Docket No. 50-346

Serial No. 1157

May 30, 1985

This letter is being submitted in regards to an inspection conducted by Region III on November 26-30, 1984 (Log No. 1-1093, Inspection Report 84-30). Toledo Edison committed, per Open Item 346/84-30-02, to contact the office of Nuclear Reactor Regulation (NRR) regarding the station vent stack monitor sample stream. The Inspection Report open item states:

VENT MONITOR FLOW PATH (TYP. OF TWO)

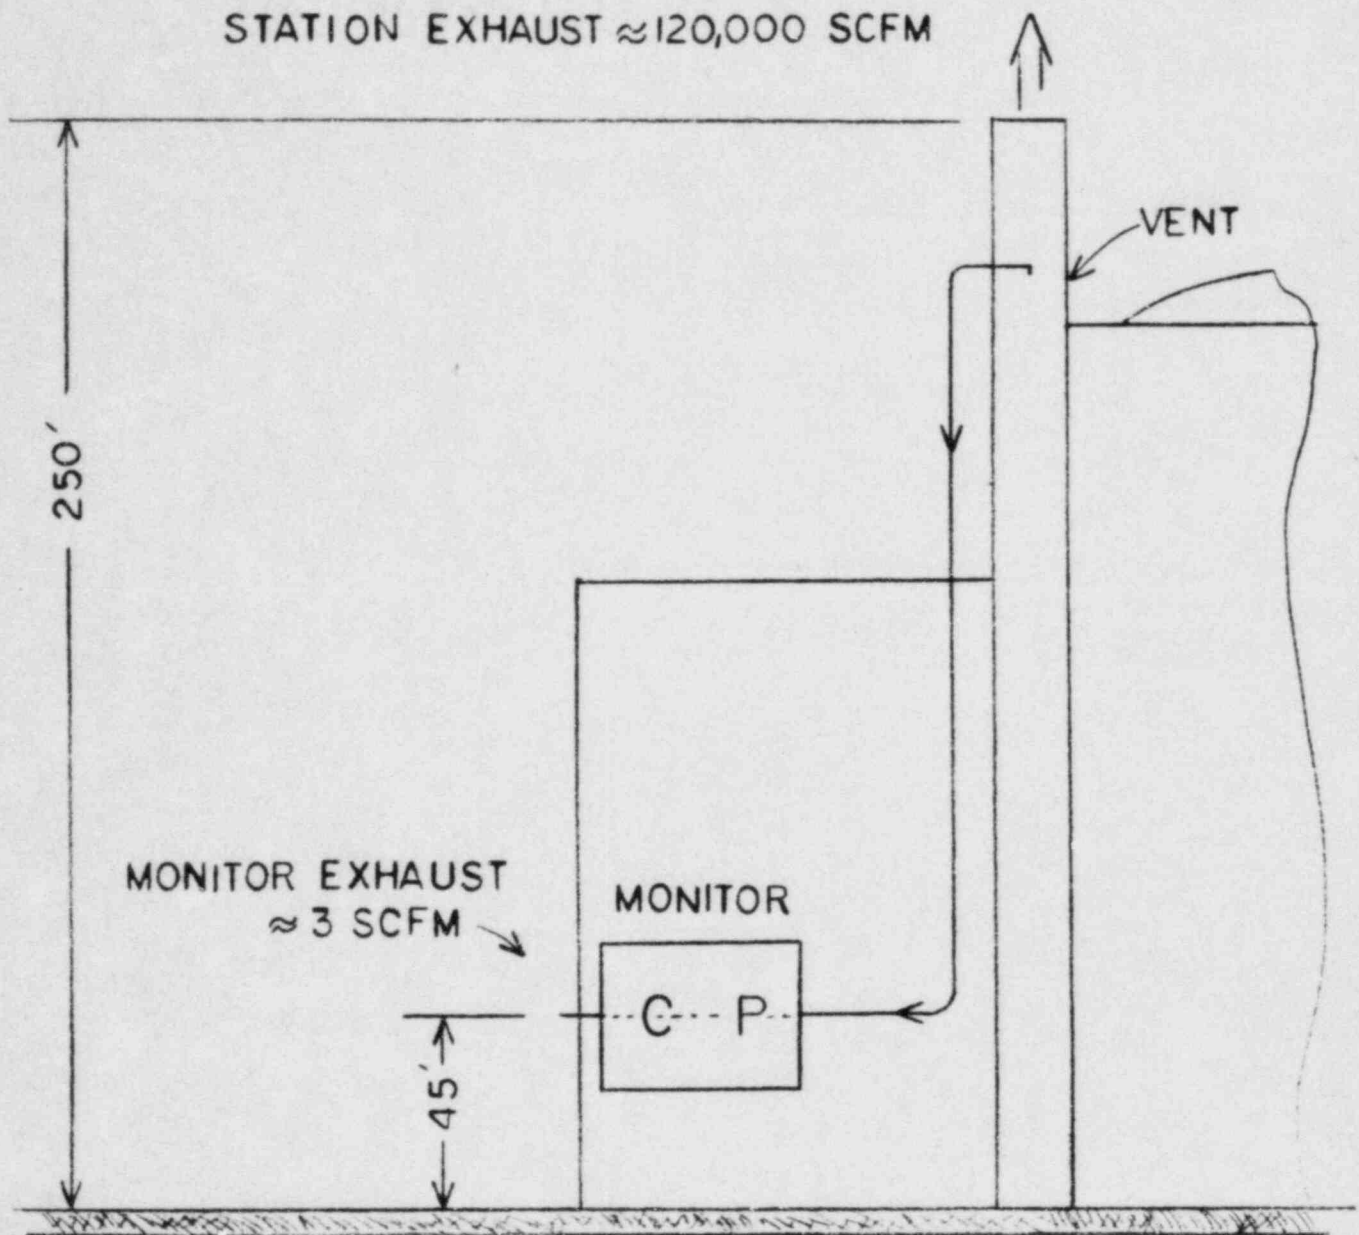
During a previous inspection, licensee representatives stated the sample stream drawn from the stack into the monitor is exhausted outside the turbine building. This matter was referred to the Meteorological and Effluents Treatment Branch of NRR for review in accordance with Standard Review Plan (SRP) 11.5. NRR's evaluation stated this sampling pathway is not consistent with Acceptance Criteria II.2.c of SRP 11.5, which indicates sample streams are to be directed back to the point of origin or to an acceptable radwaste system. This matter was discussed with the Station Superintendent who agreed to contact NRR regarding the sample stream return by June 1, 1985.

The location of the vent monitor exhaust to the environment is not significant from an activity release standpoint because all radioactivity in the monitored effluent stream (station vent stack) is directly released to the atmosphere.

2. Sample flow rate is approximately 3.0 SCFM for each of the two vent monitors. This compares to a vent stack flow rate (release rate) of typically 120,000 SCFM. The difference in release points is in elevation only as the station vent stack exhausts 250 feet Above Ground Level (AGL) and the monitor exhausts 45 feet AGL.

Additional filtering takes place within the radiation monitors as particulate and charcoal filters are part of the sample path. Attachment 1 represents the vent stack sample stream flow path and release points.

3. Design of the station vent stack monitor with tubing delivering the exhaust back to the vent (greater than 125 feet of tubing) would not only be unnecessary, but would increase the back pressure on the sample pump, reducing the sample inlet flow rate.

The reduction in sample inlet flow rate would increase sample line plateout of particulates, providing a less representative sample. The present monitor exhaust design (short exhaust line) minimizes sample pump back pressure and the resulting sample line plateout.

Acceptance criteria II.2.c of SRP 11.5 is not applicable to the station vent stack monitor because the monitored sample stream is an effluent release pathway and not a radwaste process stream. The present sample stream configuration is acceptable from a radioactivity release standpoint and obtains a sample more representative of the vent stack activity than a design that routed the monitors' exhaust back to the station vent.
